Request	-	Special Use Permit for Community Recreation-Active
Location	-	3166 Hill Avenue
Applicant + Owner	-	Aysen Investments LLC 649 W. Front Street Perrysburg, OH 43551
Engineer	-	Cappelletty Engineering – Construction 6145 Douglas Road Toledo, OH 43613

The staff recommends that the Toledo City Plan Commission recommend approval of SUP-7003-23, a Special Use Permit for Community Recreation-Active at 3166 Hill Avenue to the Toledo City Council, for the following two (2) reasons:

SPECIAL USE PERMIT
TOLEDO CITY PLAN COMMISSION
REF: SUP-7003-23
DATE: September 14, 2023
TIME: 2:00 P.M.

SITE PLAN
3166 HILL AVE.

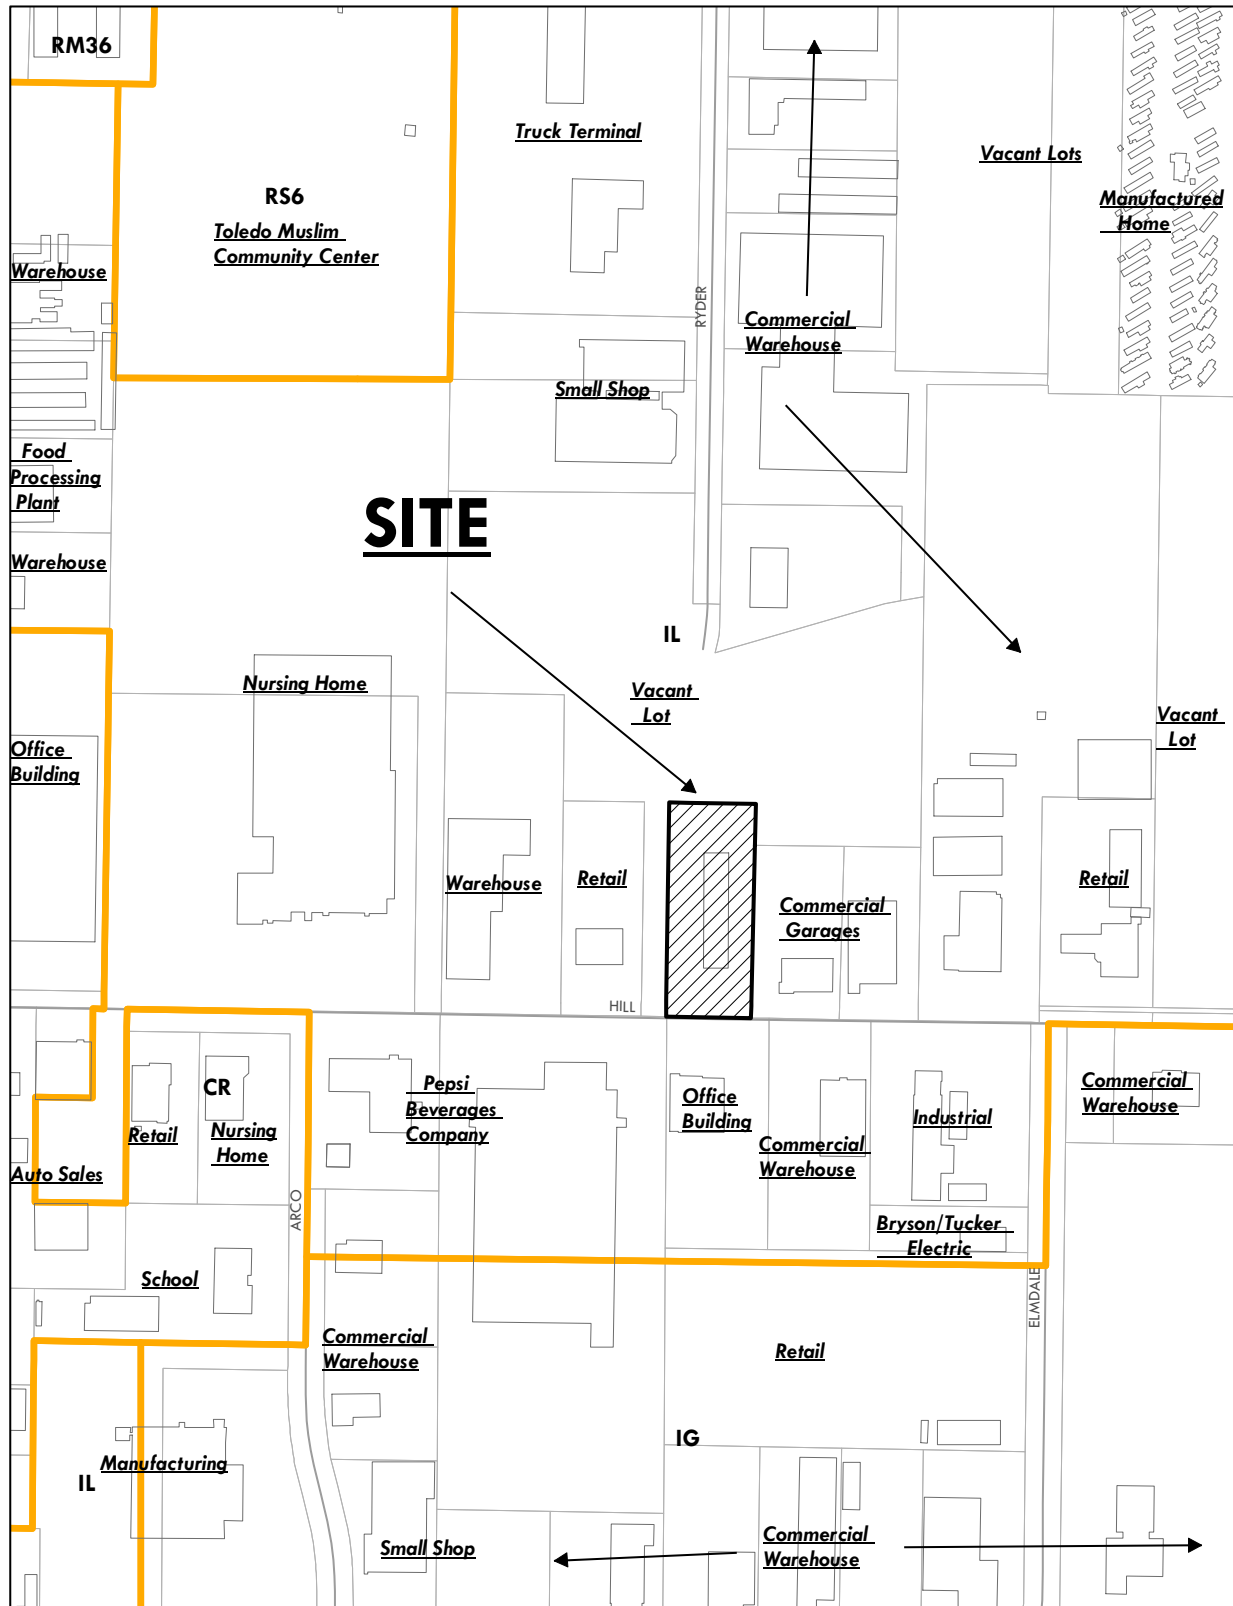
A portion of the total number of required off-street parking spaces must be specifically designated, located, and reserved for use by persons with physical disabilities. According to the table in TMC§1107.1701 – *Number of Required Parking Spaces for Persons with Disabilities*, the applicant is required to provide at least one (1) van accessible space with an eight-foot (8') drive aisle and two (2) car accessible space with five-foot (5') drive aisles for persons with physical disabilities. The site plan shows two (2) accessible parking spaces included in the designated twenty-eight (28) parking spaces for the community recreation use. This is not acceptable as depicted. One additional accessible space shall be provided with an accessible aisle in compliance with TMC§1107.1701 on a revised site plan.

Bicycle parking is required pursuant to Off-Street Parking Schedule “A” (TMC§1107.0300). A minimum of one (1) bicycle space shall be provided per ten (10) automobile parking spaces. The site plan does not show any bicycle parking spaces. Six (6) bicycle spaces are required for the community recreation center. This shall be shown on a revised site plan.

Additionally, TMC§1107.1303 requires sidewalks to be provided along all public streets in commercial districts. A public sidewalk shall be provided along Hill Avenue on a revised site plan. Furthermore, per TMC§1107.1906, Off-street parking and loading spaces, parking lots, maneuvering areas, aisles and driveways shall be surfaced with concrete, bituminous asphalt, or other dust-free material other than gravel or loose fill. The submitted site plan depicts the private driveway servicing the site and the drive aisle in the rear of the site surfaced with gravel. A revised site plan shall be submitted complying to TMC§1107.1906.

The site is existing and per **TMC§1114.0502(A)** is required to be brought closer into compliance with the 2004 landscape standards. As required under **TMC§1108.0202** a fifteen-foot (15') greenbelt is required along Hill Avenue. However, staff recommends a ten-foot (10') buffer as the site is existing and cannot provide a fifteen-foot buffer (15'). At least one tree must be provided for every 30 feet of lot frontage or fraction thereof. The frontage greenbelt shall also include a solid evergreen hedge to screen parking in the front of the property and prevent headlights from being seen from the right-of-way. Six (6) trees and continuous shrubs are required along Hill Avenue. Applicant has the option to request credit for existing trees under **TMC§1108.0407(B)(9)**. The applicant shall submit a landscaping plan in compliance with **TMC§1108.0202**.

In addition to that, **TMC§1108.0204(B)(9)** requires perimeter landscaping to be installed along any parking lot area adjacent to a street, place, or driveway, or which is visible from an immediately adjacent property, and must include a continuous shrub row with a minimum height eighteen inches (18"). Perimeter landscaping must consist of a landscape area at least 10 feet in width, exclusive of sidewalks, walkways, trails, or right-of-way and must be located between the parking lot and the property line. **Not acceptable as depicted. Landscaping shall be provided along parking spaces facing private drive and along the east property line.**

25. Any spaces reserved for the use by persons with physical disabilities shall adhere to the standards outlined in TMC§1107.1700. One (1) van accessible space with an eight-foot (8') drive aisle and two (2) car accessible space with five-foot (5') drive aisles are required. **Not acceptable as depicted on submitted site plan. One additional accessible space shall be provided with an accessible aisle in compliance with TMC§1107.1701 on a revised site plan.**

26. Bicycle parking slots shall be provided pursuant to Off-Street Parking Schedule “A,” (TMC§1107.0300). Minimum number of bicycle parking slots required for a community recreation – active is one (1) per ten (10) parking spaces. **Not acceptable as depicted on site plan. Six bicycle parking spaces shall be shown on a revised site plan.**

27. Off-street parking and loading spaces, parking lots, maneuvering areas, aisles and driveways must be surfaced with concrete, bituminous asphalt, or other dust-free material other than gravel or loose fill, and be graded to drain all surface water towards the interior of the parking lot or to a stormwater treatment facility subject to the regulations and approval of the Department of Public Utilities. **Not acceptable as depicted on submitted site plan. Private driveway servicing the site and the drive aisle in the rear of the site shall be shown in compliance with TMC§1107.1906 on a revised site plan.**

28. Whenever a parking lot extends to a property line, sidewalk, planting strip, or building, a wheel stop device consisting of a concrete stop, a permanent concrete curb, an expanded sidewalk or other suitable restraint as approved by the Planning Director must be installed to prevent any part of a parked motor vehicle from extending beyond the property line, overhanging a pedestrian walkway or sidewalk, or damaging any structure or landscaping (TMC§1107.1907(A)). **Not acceptable as depicted on site plan. Wheel stops shall be shown on a revised site plan for parking spaces along the west, east, and south property lines.**

29. TMC§1107.1303 requires sidewalks to be provided along all public streets in commercial districts. **A public sidewalk shall be provided along Hill Avenue on a revised site plan.**

- a. A ten-foot (10') greenbelt of landscaped frontage greenbelt is required along Hill Avenue. At least one tree must be provided for every 30 feet of lot frontage or fraction thereof. The frontage greenbelt shall also include a solid evergreen hedge to screen parking in the front of the property and prevent headlights from being seen from the right-of-way. Six (6) trees and a continuous shrub are required along Hill Avenue. Applicant has the option to request credit for existing trees under TMC§1108.0407(B)(9). **Not acceptable as depicted. Applicant shall submit a landscaping plan in compliance with TMC§1108.0202;**

- b. Perimeter landscaping must be installed along any parking lot area adjacent to a street, place, or driveway, or which is visible from an immediately adjacent property, and must include a continuous shrub row with a minimum height eighteen inches (18"). **Not acceptable as depicted. Landscaping shall be provided along the parking spaces facing the private drive and along the east property line;**
